# SERVICE BULLETIN **Buell**<sup>®</sup>

B-024B

## SAFETY RECALL CODE 0817 - REVISED SHOCK EYE

Figure 2. New Shock Absorber Assembly

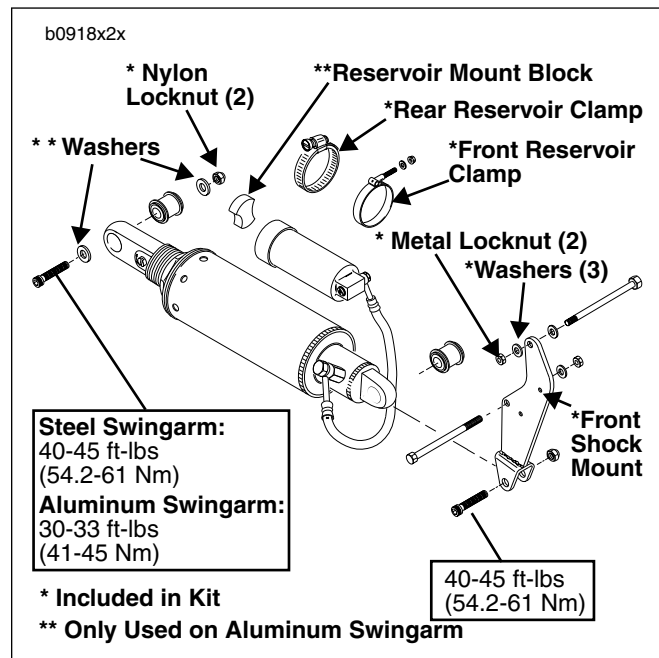
The new front shock mount **MUST** be used with the new shock absorber. The new shock is 1.77 in. (45 mm) shorter than the previous shocks and requires the new front mount to align and install properly.

1. See Figure 2. Install **new** front shock mount to crankcase with two **new** front shock mount bolts, washers, star washer (on 1997 M2, S3/S3T models only) and metal locknuts. Tighten bolts to 30-33 ft-lbs (41-45 Nm). **NOTE:** Top bolt goes in from the left side, bottom bolt goes in from right side. Bottom bolt does not use washer under bolt head. Star washer (only used on 1997 M2, S3/S3T models) goes on bottom bolt under the washer on the nut side. If exhaust was loosened during front shock mount removal, replace exhaust gaskets and reinstall exhaust. See appropriate Service Manual, Section 2 for instructions.

4. See Figure 2. Position **new** shock absorber from kit in mounting position.
5. Loosely install bolt, washers (aluminum swingarms only) and **new** locknut through rear shock eye and swing arm.
6. Loosely install bolt and **new** locknut through front shock eye and front shock mount.
7. **On 1996-1998 vehicles only:** Loosen header tie bar from collector.
8. Position front clamp over reservoir. Loosely install **new** front reservoir clamp to front shock mount (and install **new** header tie bar spacer between front shock mount and header tie bar on 1996-98 vehicles only) with **new** washer and **new** nylon locknut.
9. See Figure 3. Loosely install **new** rear clamp around reservoir and oil feed line.
10. **All Models:** Install **new** reservoir mount block between oil pump fitting and remote reservoir.

**Figure 4. Measuring Preload**

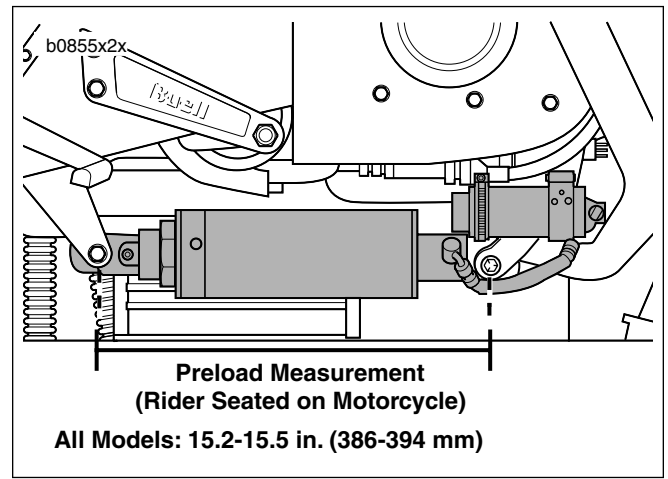
- See Figure 4. Check and adjust rear shock preload.
  - With rider seated on motorcycle, the preload is determined by measuring the distance between the centers of the front and rear shock eye and adjusting until the measurement is within specification.
  - See below for optimum preload measurements:
    - All Models:** 15.2-15.5 in. (386-394 mm)

Figure 7. Locknut Tightening Procedure

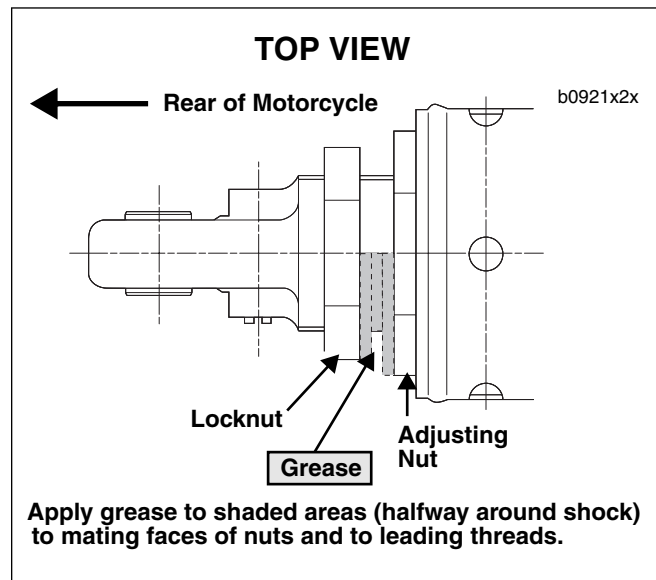
Since the release of the last bulletin (B-024A), the spring preload locknut tightening procedure has been modified (as covered in Bulletin B-037). This bulletin includes the new torque specification and tightening procedure.

- Using SHOCK PRELOAD ADJUSTING TOOLS (Part No. B-45110), hold adjusting nut in place with 60 mm ADJUSTING NUT WRENCH and tighten locknut to 65-72 ft-lbs (88-98 Nm) with 52 mm LOCKNUT CROW'S FOOT set at 90 degrees to the torque wrench.
- Wipe excess grease off of shock absorber.
